# WOLF CREEK

ET 00-0010

Subject: Docket No. 50-482: Supplemental Response to Generic Letter 96-06 (TAC NO. M96887)

**SUBJECT: Letter Report Assessment of GL96-06 Waterhammer Analysis Assumptions and Available Margin**

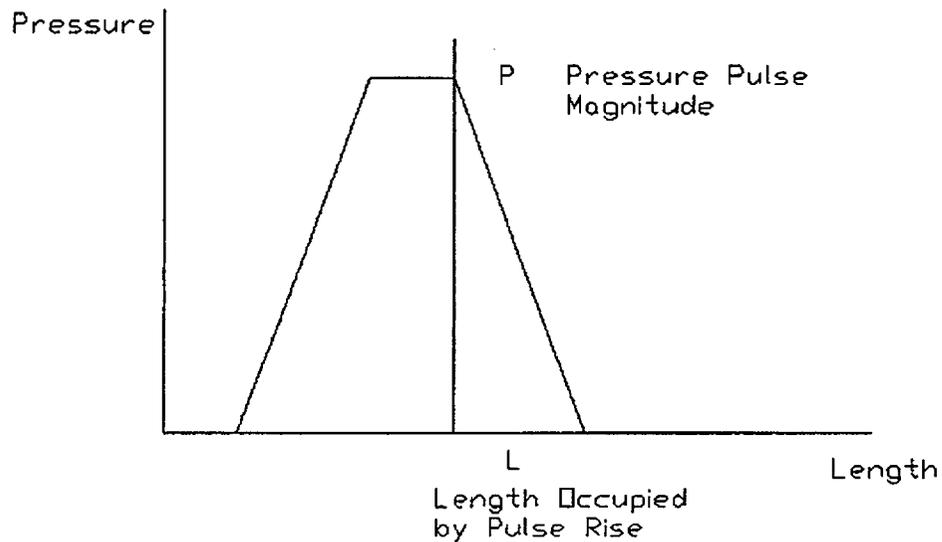
For pipes which are relatively short compared to the length occupied by the rising pressure wave, the slope of the pressure wave rise is the primary variable affecting differential pressure loading.

The rise "length" is the rise time times the sonic velocity ( $L = T_R \times C$ ). It can be seen that increasing the sonic velocity by the same amount in both the determination of pressure peak magnitude and length through which it travels will leave the slope the same. Therefore, for short piping lengths relative to the pulse rise time, the net effect of increasing the sonic velocity is zero, since the magnitude and rise slope act in opposite directions.

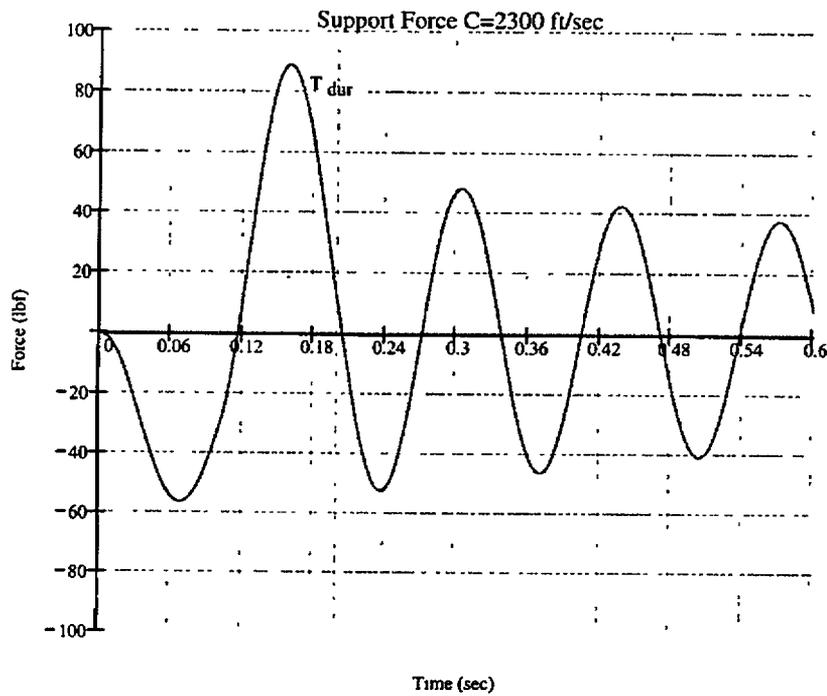
The following plot shows the resulting force on the pipe support (spring) resulting from the differential pressure across the pipe segment.

$$F_{\max 2300} = 89.33 \text{ lbf}$$

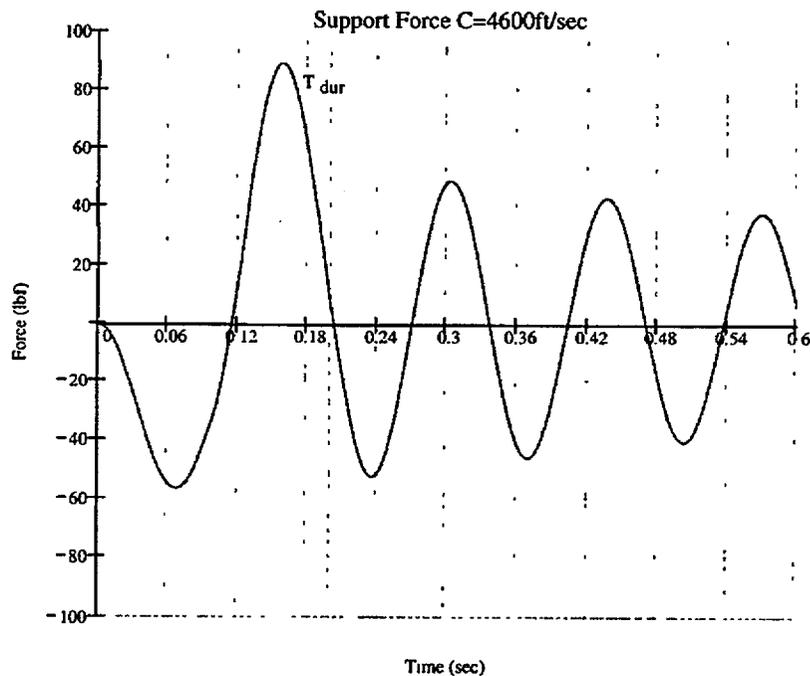
The following plot shows the resulting force on the pipe support (spring) resulting from the differential pressure across the pipe segment. The sonic velocity and pressure differential have been double but the Support Force is the same.

$$F_{\max 4600} = 89.368$$

Doubling the sonic velocity does not change the support loads as can be seen below. A review of the force-time history plots shows that the duration and other characteristics are also equivalent.
